Los Angeles to Pasadena Metro Blue Line Construction Authority
Los Angeles to Pasadena Metro Blue Line Light Rail Project

Value Engineering Study Report

Preliminary Basis for Design/Build Design

December 22, 1999

ALTERNATIVE NO. US-2
 Sht. 3 of 7

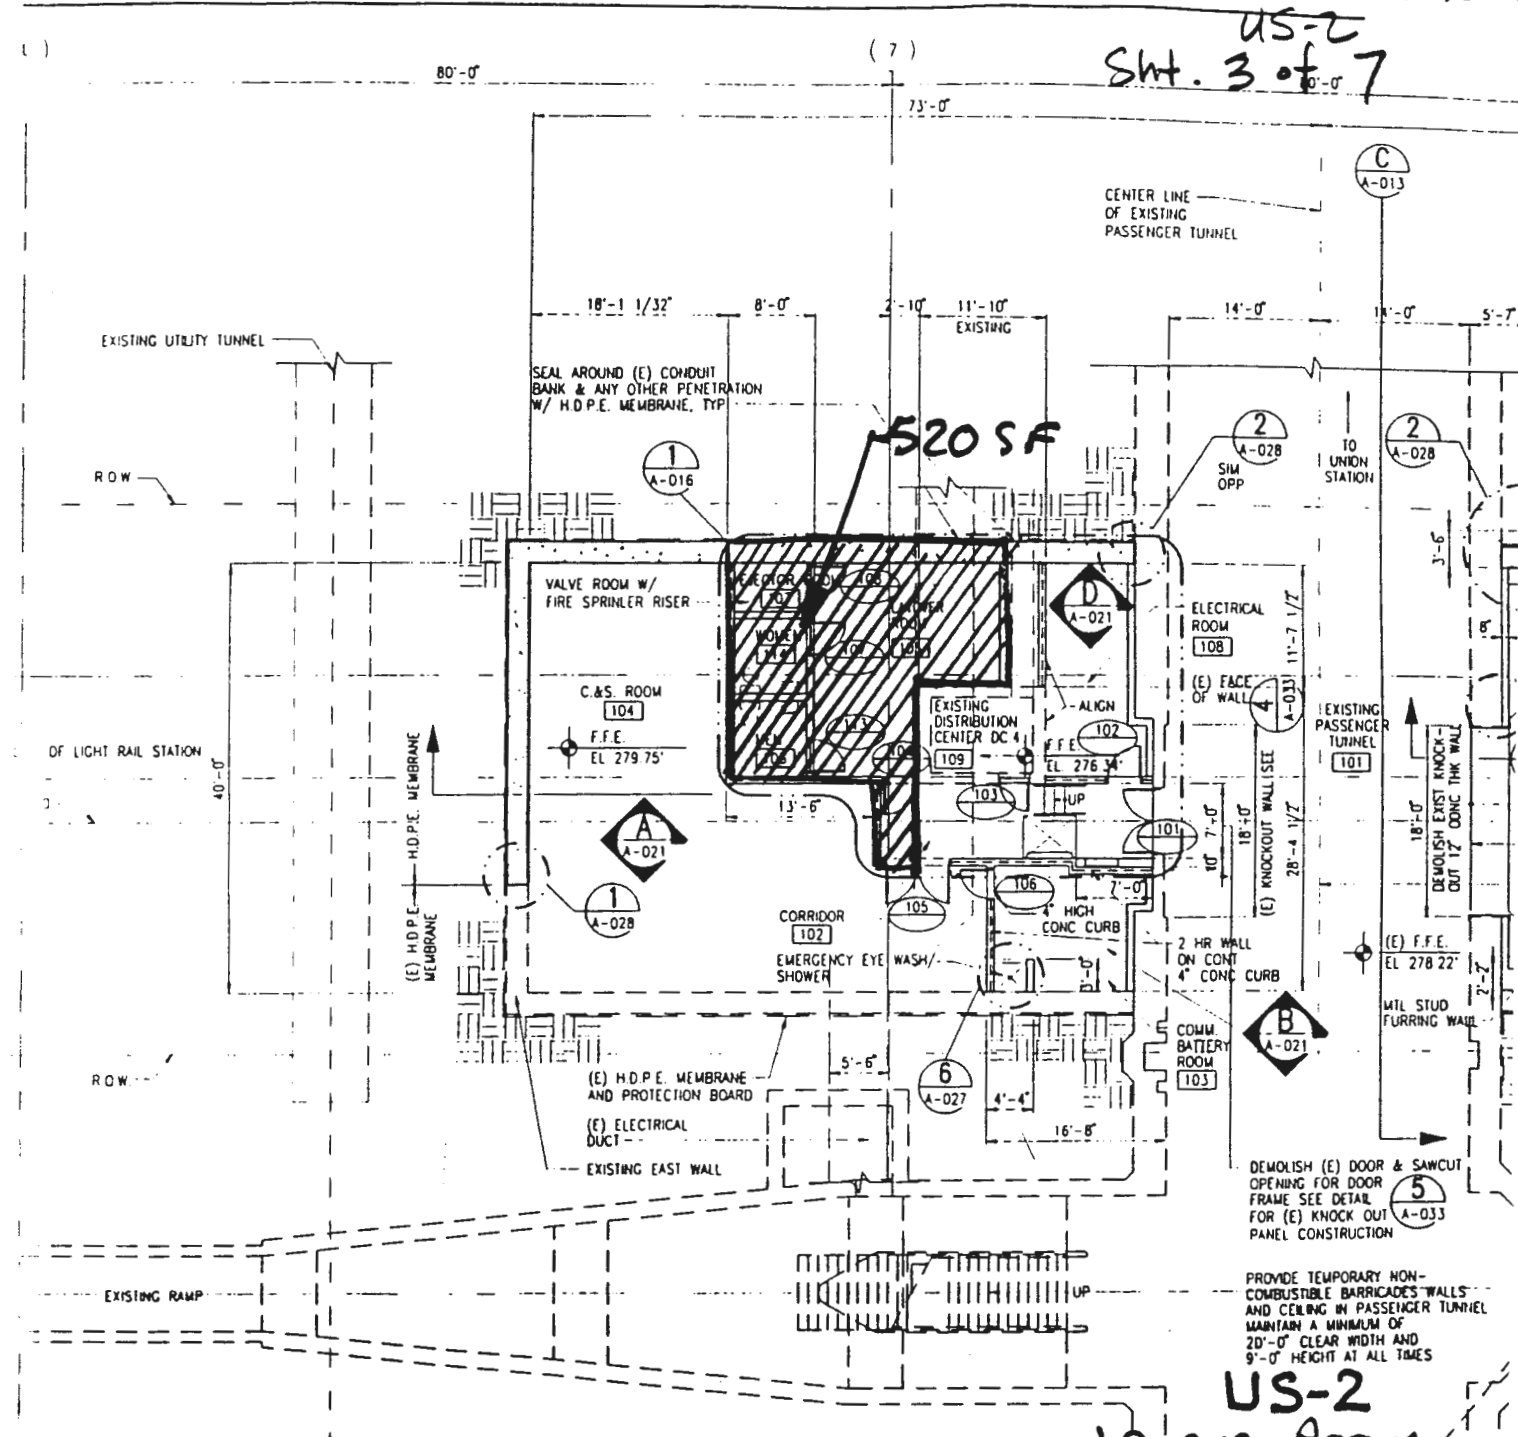
Access to layover room will no longer require train operators to go into a tunnel room. Thus, operators will be adjacent to station platform and be able to monitor their rail cars.

ALTERNATIVE NO.
US-6
Sht. 3 of 4

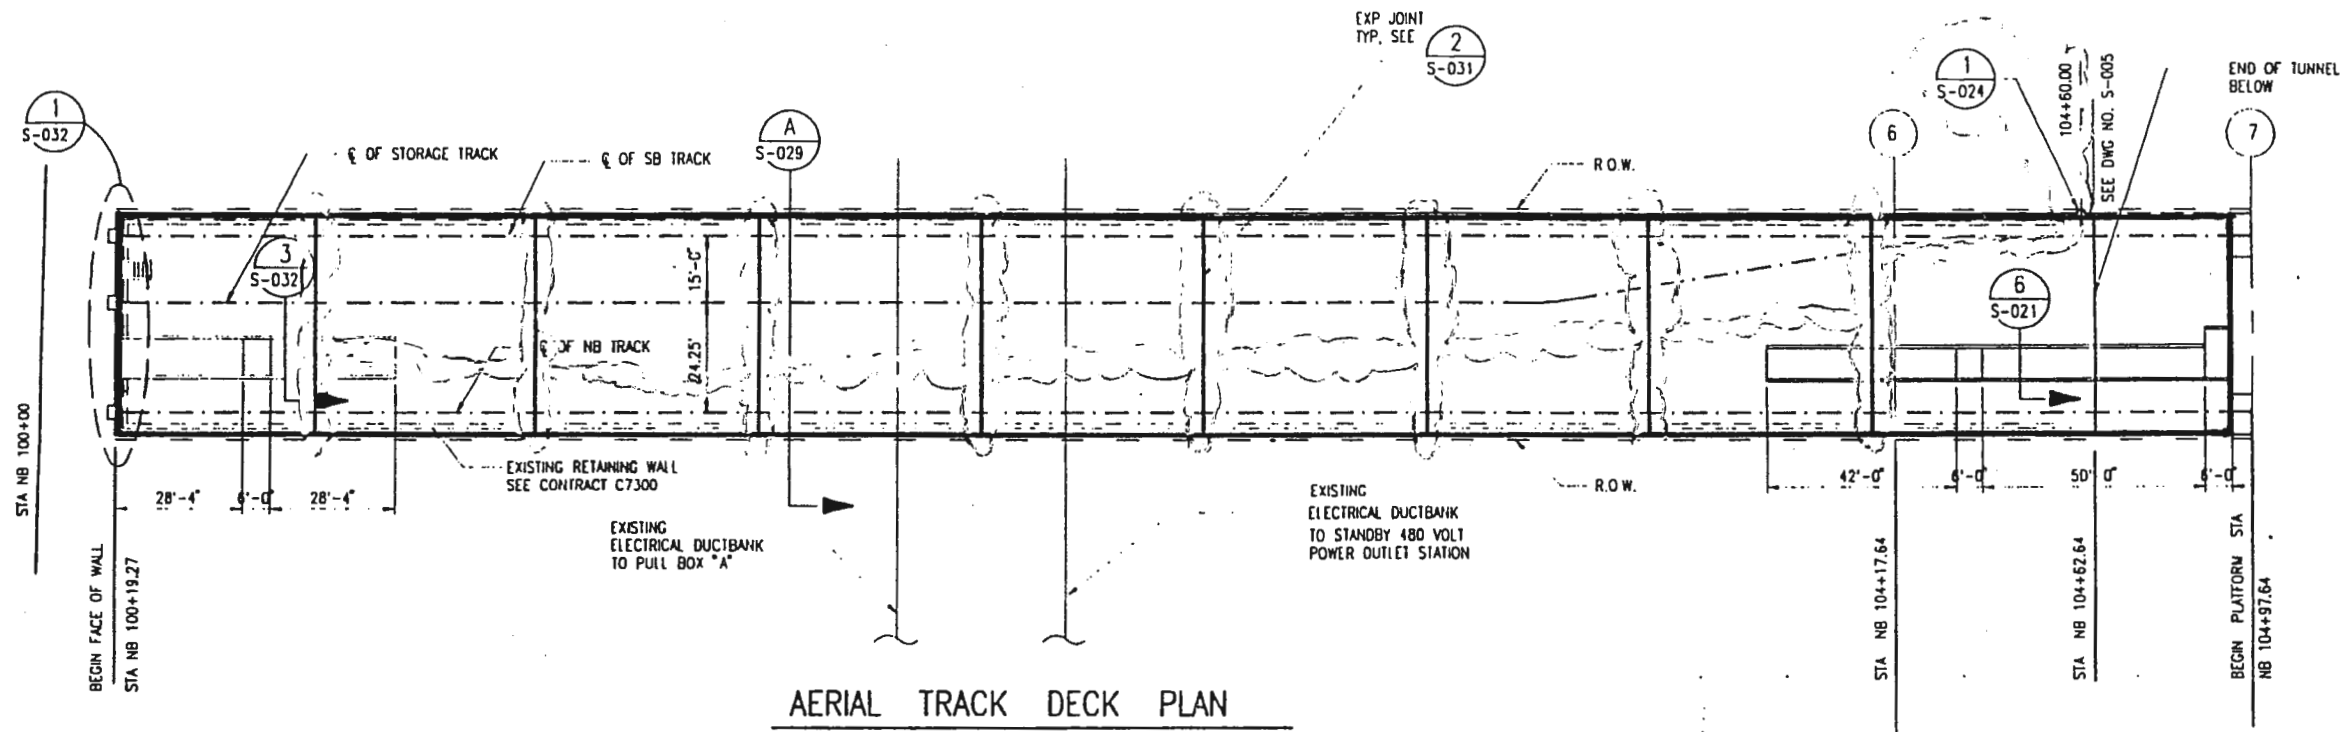
COST SUMMARY	INITIAL COST	RECURRING COSTS	PRESENT WORTH LIFE-CYCLE COST
ORIGINAL DESIGN	\$ 254,809	—	\$ 254,809
ALTERNATIVE	\$ 74,816	—	\$ 74,816
SAVINGS	\$ 179,993	—	\$ 179,993

ALTERNATIVE NO.
ETS-4
Sht. 2 of 4

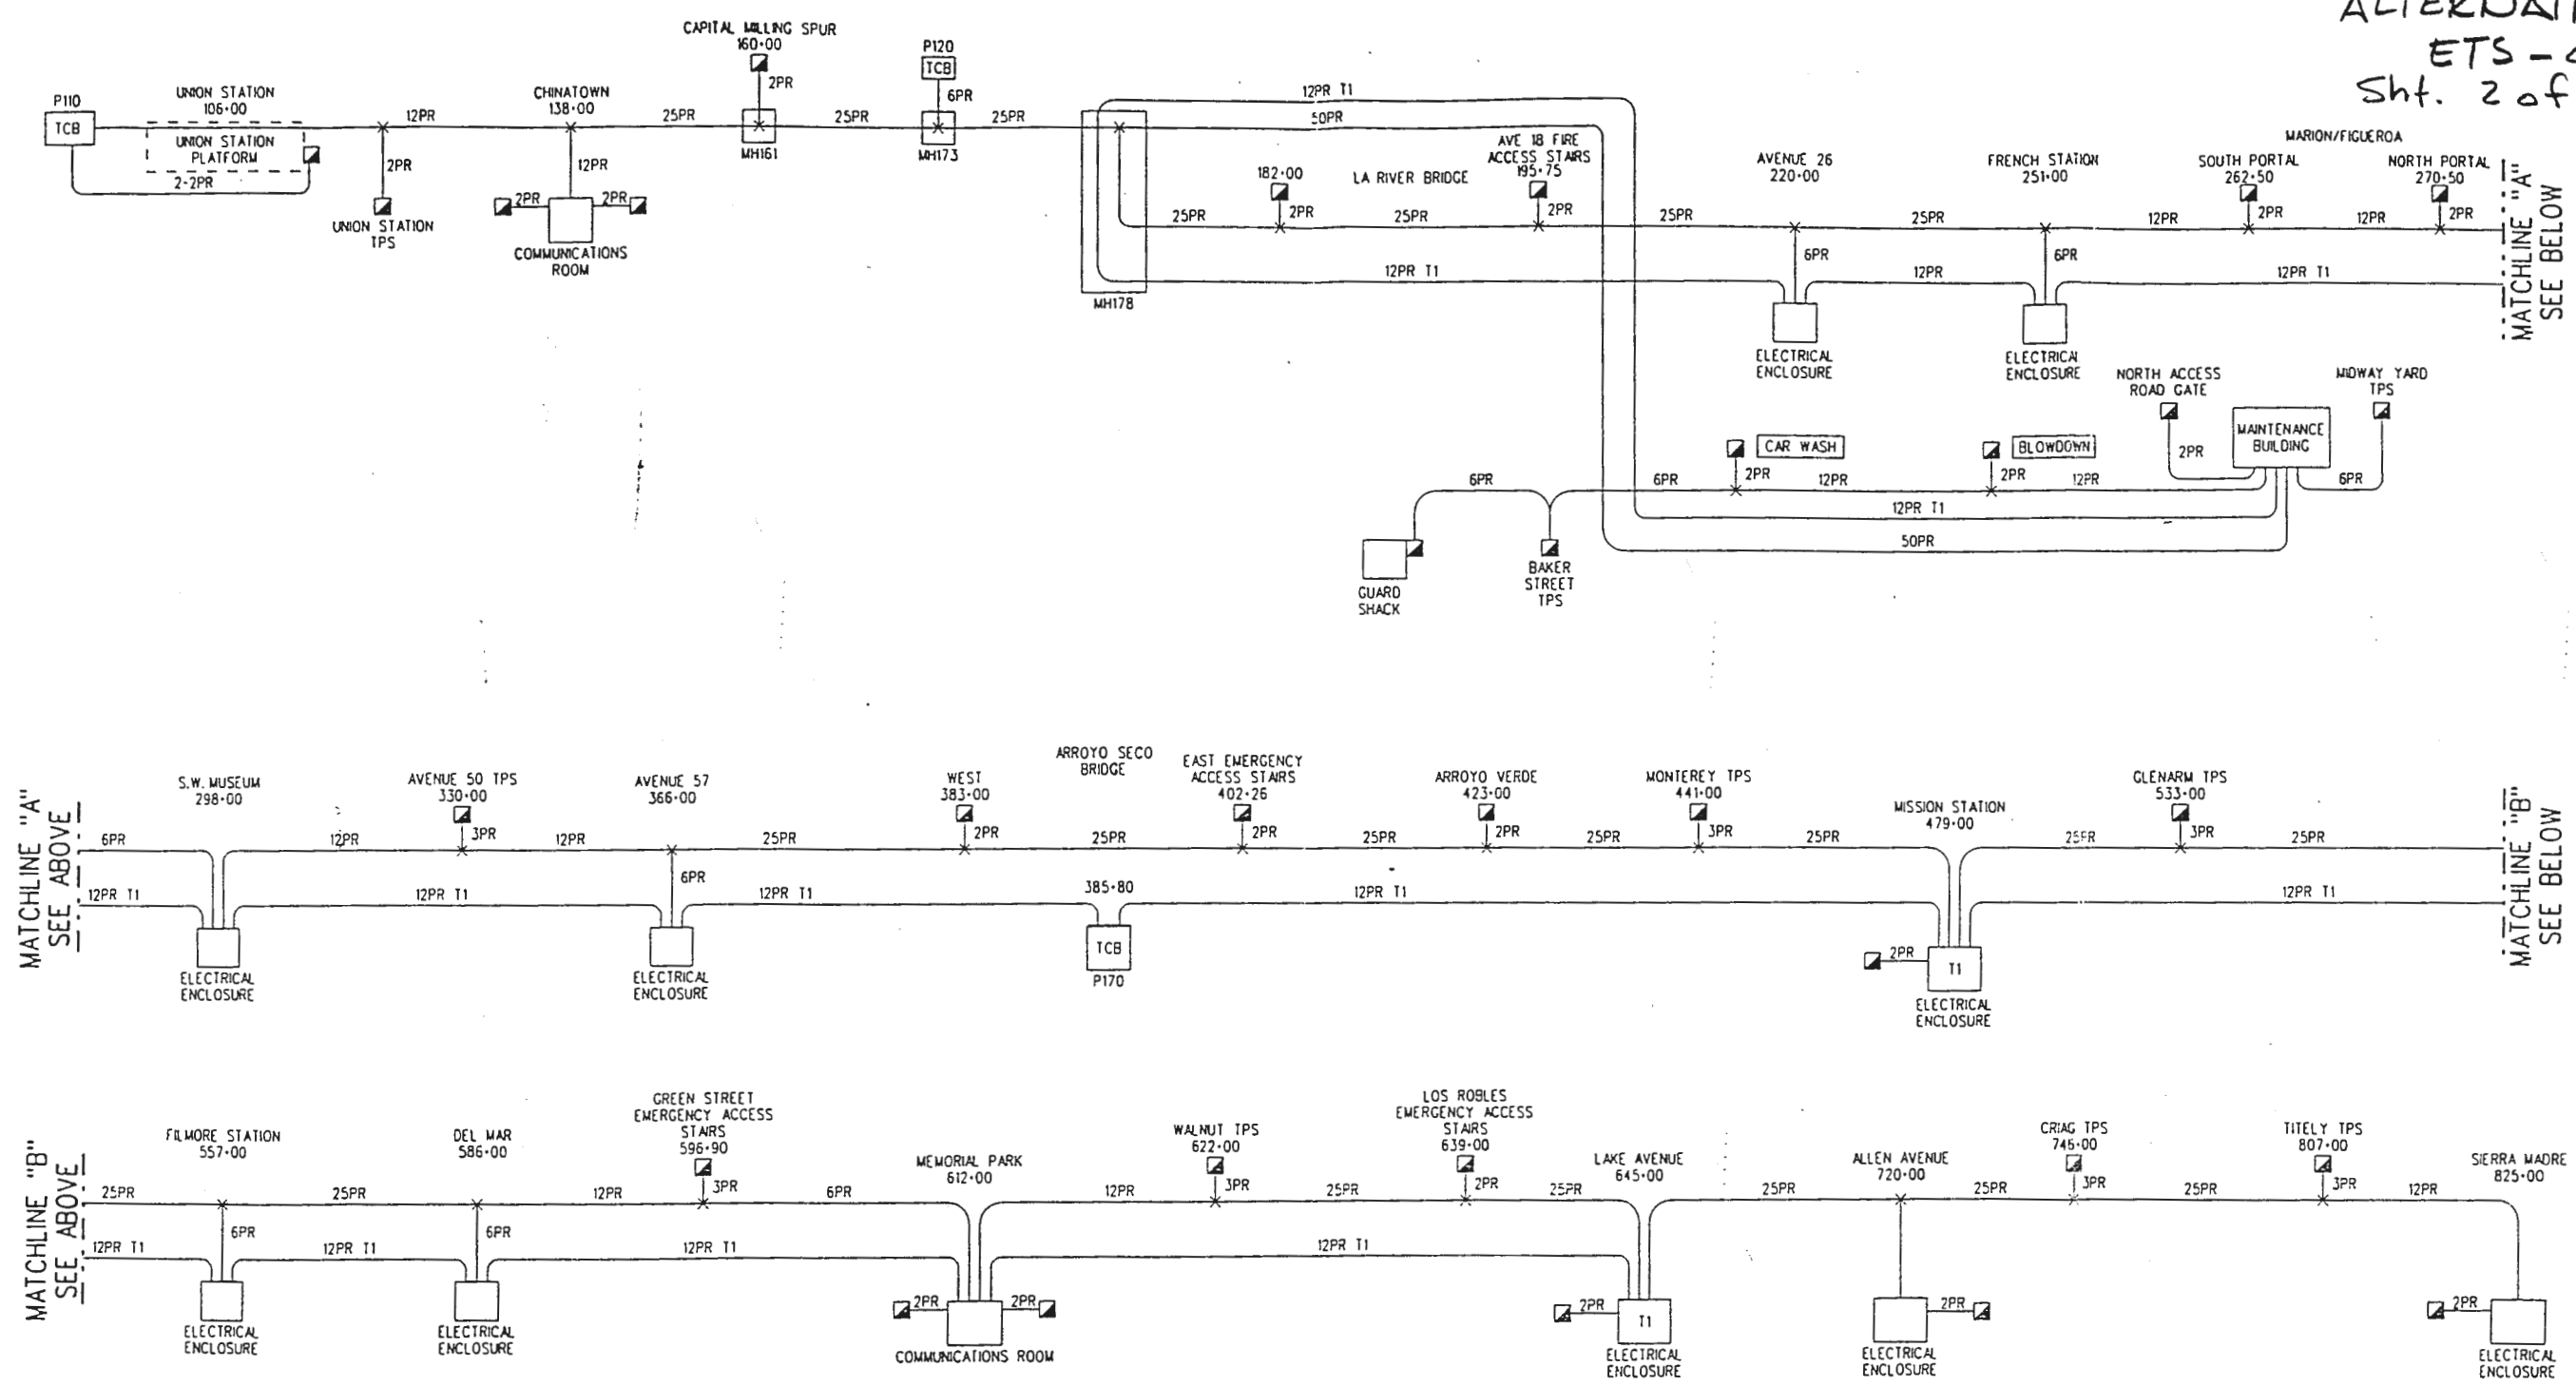
PROJECT: PASADENA BLUE LINE LIGHT RAIL PROJECT		LOCATION: LOS ANGELES TO PASADENA, CALIFORNIA				
PROJECT ELEMENT: SYSTEMS		PRESENT WORTH OF COST SAVINGS				
ALT. NO.	DESCRIPTION	ORIGINAL COST	ALTERNATIVE COST	INITIAL COST SAVINGS	O & M SAVINGS	TOTAL SAVINGS
	DYNAMIC SIGNAGE (DY)					
DY-2	Sell advertising on dynamic signage at stations	DESIGN SUGGESTION				
DY-3	Replace dynamic signage with Closed Circuit Television screens	751,867	751,867	0	—	0
DY-5	Have MTA procure dynamic signage	751,867	112,780	639,087	—	639,087
	RADIO SYSTEM (RS)					
RS-2	Have MTA procure radio system	2,367,145	355,072	2,012,073	—	2,012,073
	EMERGENCY TELEPHONE SYSTEM (ETS)					
ETS-1	MTA will procure emergency telephone system	1,311,240	131,124	1,180,116	—	1,180,116
ETS-2	Include ETS in fiber optic backbone	1,311,240	631,368	679,872	—	679,872
ETS-4	Lease dedicated telephone lines for emergency telephone system	1,311,240	44,600	1,266,640	(528,570)	782,670
